URGENT PRODUCT RECALL

Baxter Healthcare Corporation is issuing an Urgent Product Recall for the **Q-link** 13 lift component due to customer reports related to the improper attachment of the **Q-link** 13 (false latching) with the quick-release hook. See Figure 1 below.

Figure 1. Correct vs Incorrect attachment of **Q-link** 13 with the quick-release hook

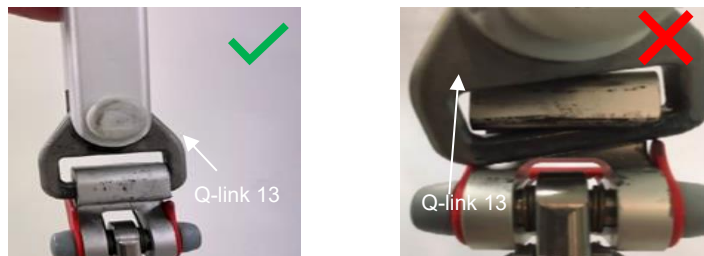
The **Q-link** 13 allows for an improper attachment (false latching) of the quick-release hook used on sling bars and other accessories. This could result in a critical injury from a patient fall, as the incompletely latched component may initially bear weight but can loosen from the **Q-link**, resulting in detachment and drop. There were three reports of

Baxter will replace all affected **Q-link** 13 products with the new **Q-link** Mobile to improve ease of use and mitigate potential risk to patients or caregivers. A follow-up communication will be provided once sufficient **Q-link** Mobile components are available for distribution, and will include instructions to request replacements.

1. **Please locate and stop using all Q-link 13 components on any of the products listed in the affected product table.**
2. **Contact Baxter Technical Support to discuss alternative options, if necessary, at 800-445-3720, option 2, between the hours of 8:00 am and 6:00 pm Eastern Time, Monday through Friday, or by email at HRC_Technical_Support@Baxter.com.**
